6/24/14	Added New Sheet.
DATE	REVISION
STATE OF HAWAII DEPARTMENT OF TRANSPORTATION HIGHWAYS DIVISION	
WATER POLLUTION & EROSION CONTROL NOTES	
HALEAKALA HIGHWAY INTERSECTION IMPROVEMENTS AT KULA HIGHWAY Project No. 37C-01-14	
Date: June, 2014	
SHEET No. 1 OF 3 SHEETS

6/24/14	Added Notes.
DATE	REVISION
STATE OF HAWAII DEPARTMENT OF TRANSPORTATION HIGHWAYS DIVISION	
TYPICAL SECTIONS & DETAILS	
HALEAKALA HIGHWAY INTERSECTION	
IMPROVEMENTS AT KULA HIGHWAY	
Project No. 37C-01-14	
Scale: As Shown	Date: April, 2014
SHEET No. 1 OF 3 SHEETS

DEMOLITION PLAN

**HALEAKALA HIGHWAY INTERSECTION
IMPROVEMENTS AT KULA HIGHWAY**

CURB RAMP PLANS

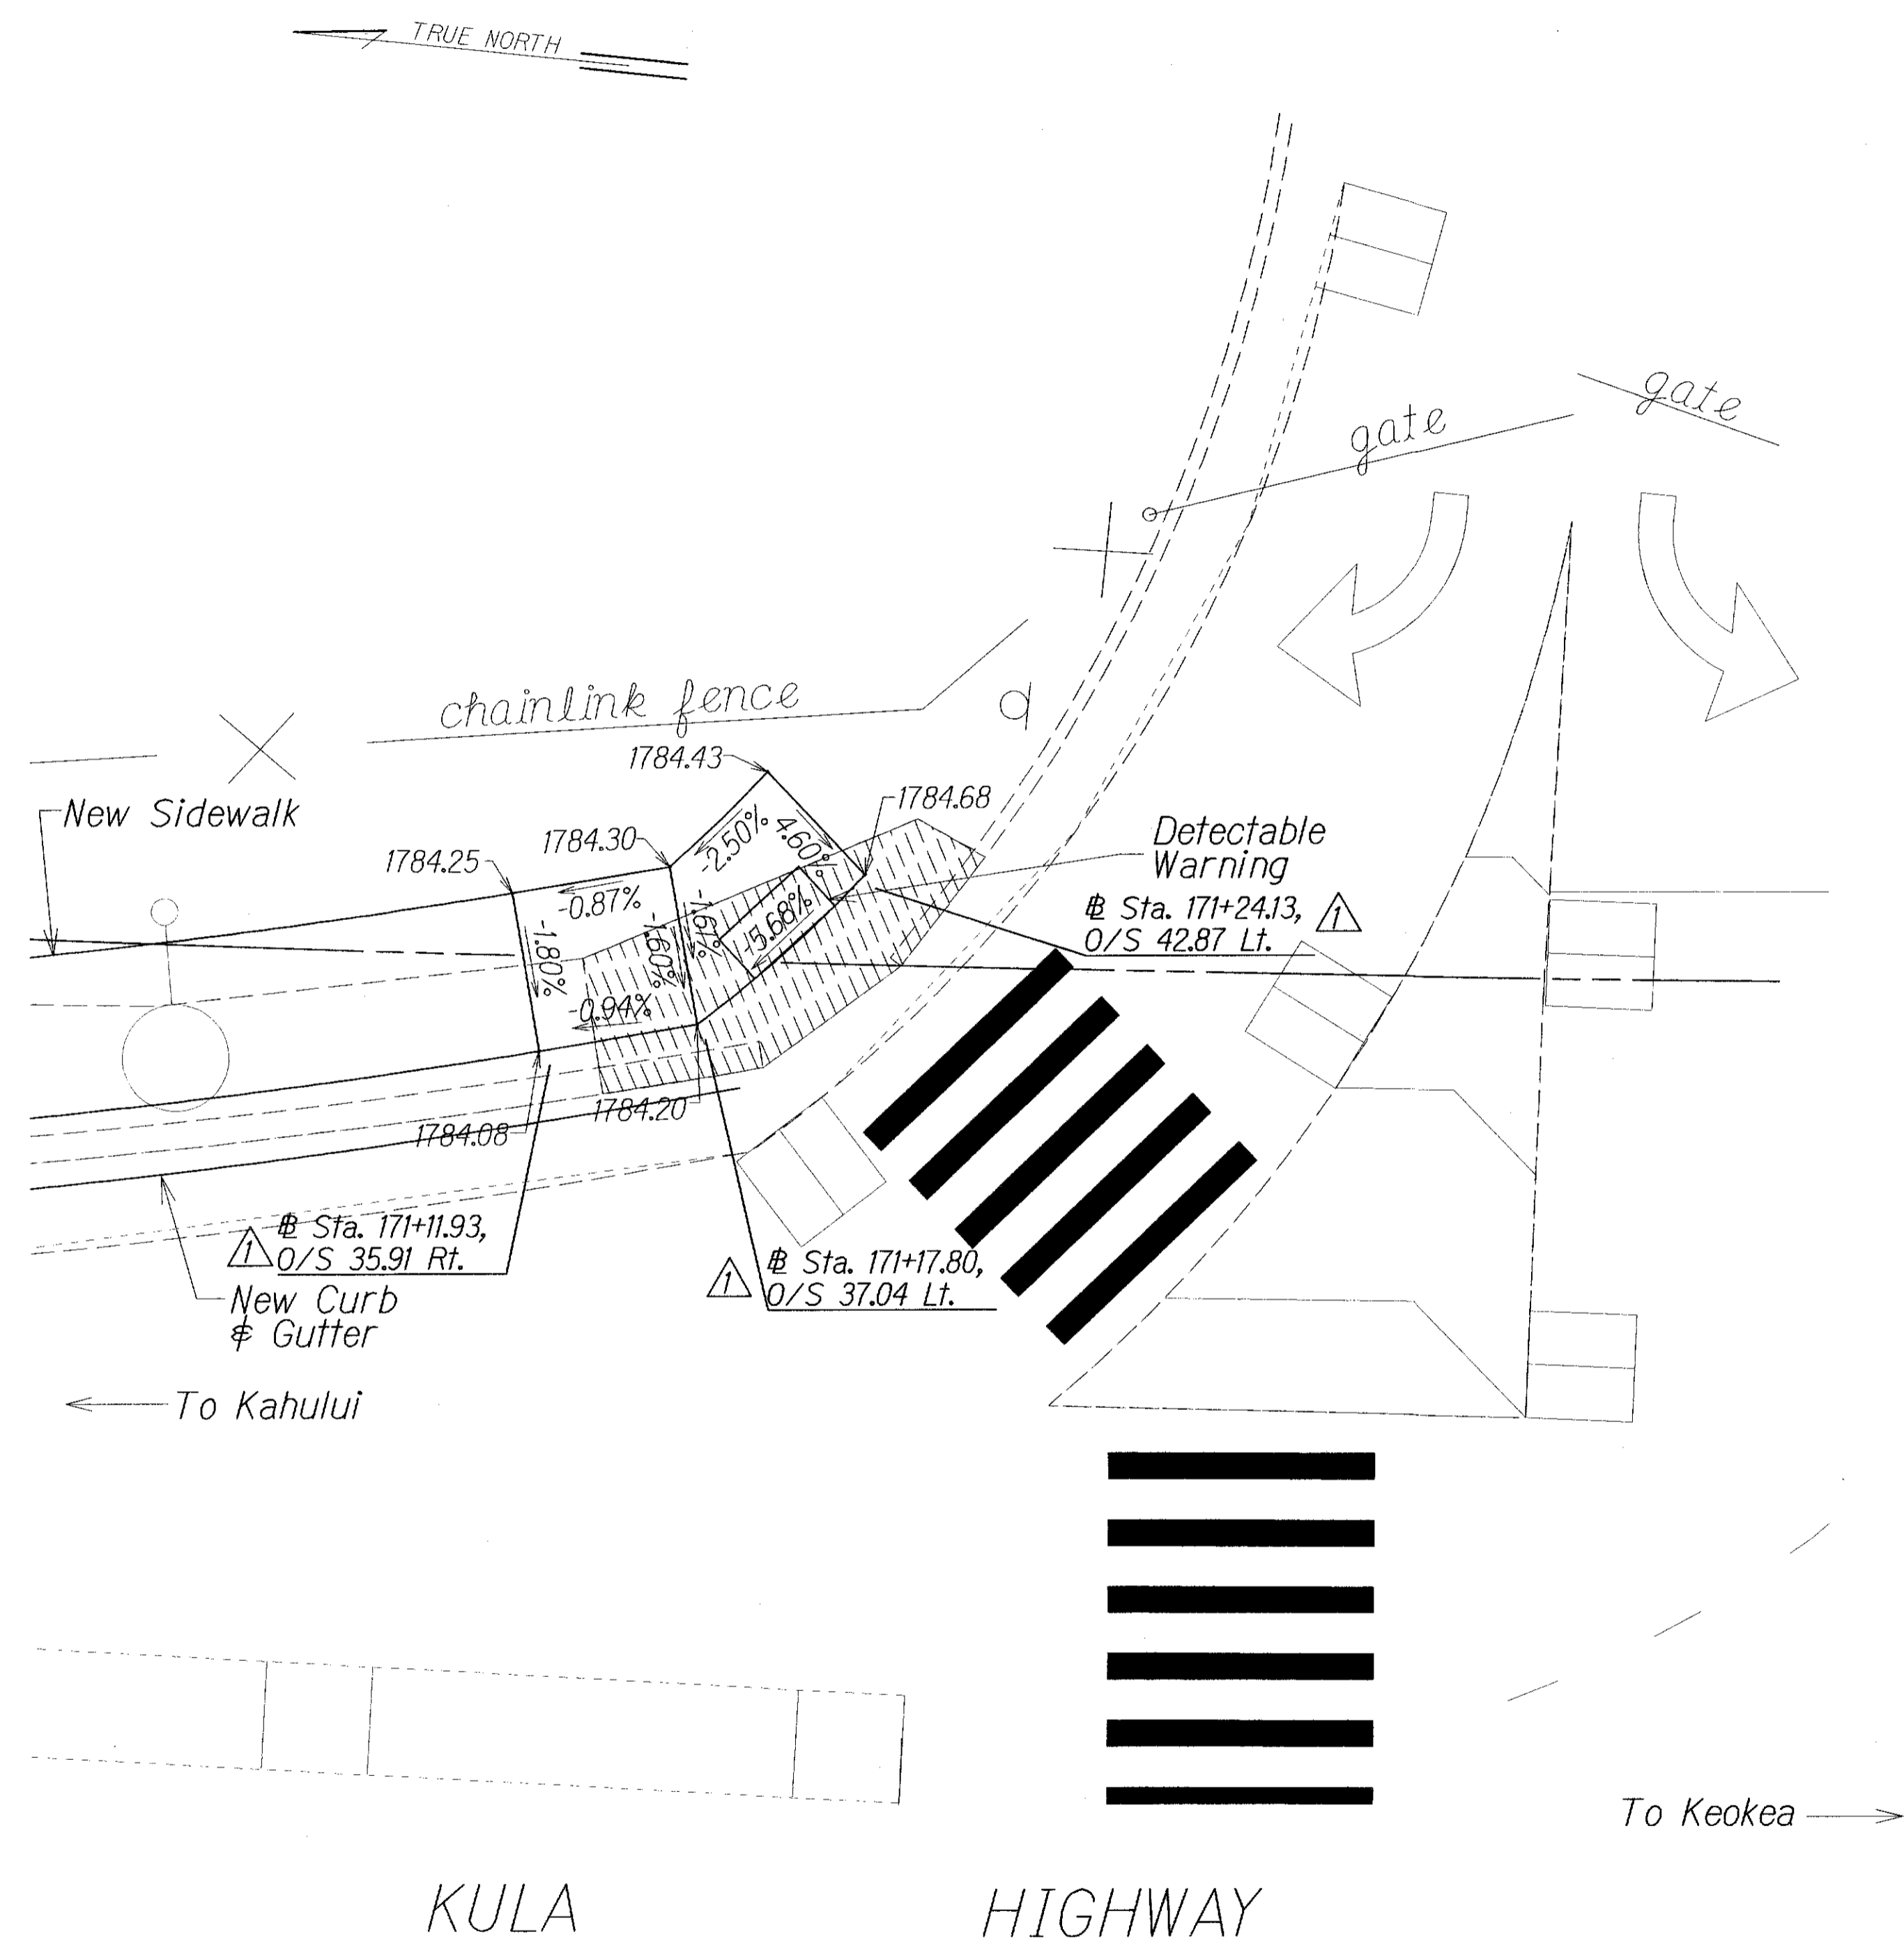
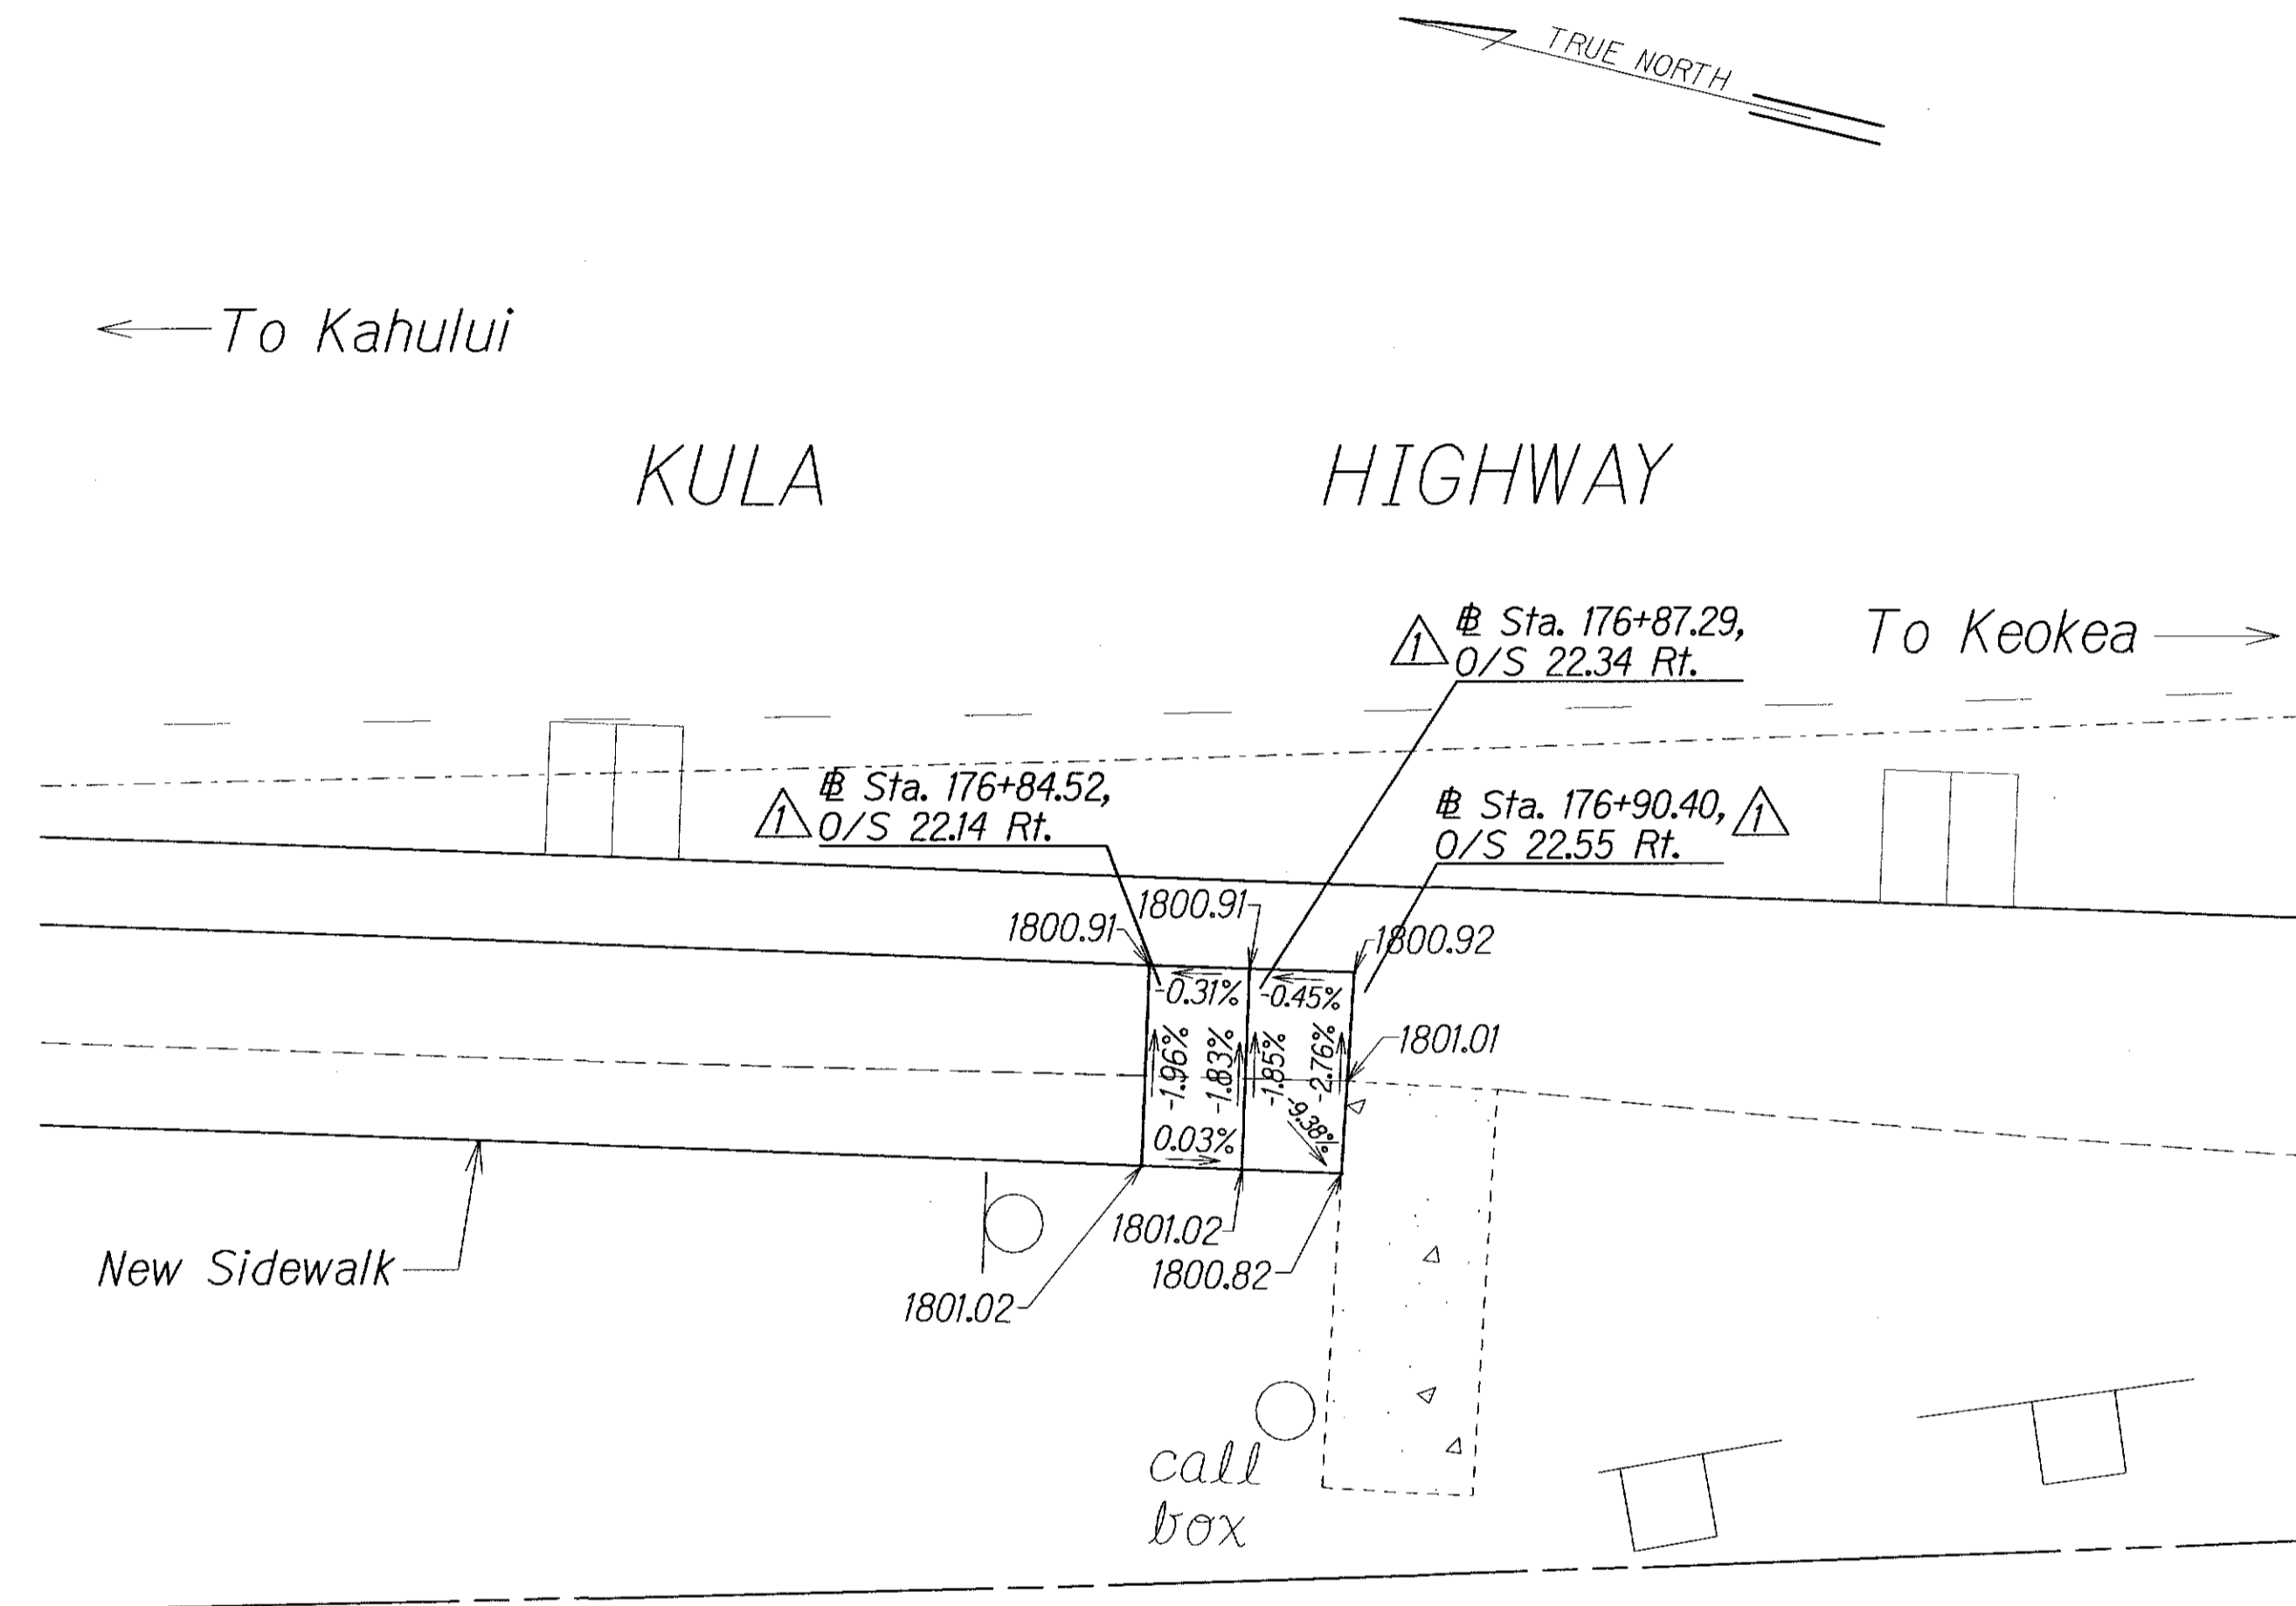
6/24/14	Added Station Numbers and Offsets.
---------	------------------------------------
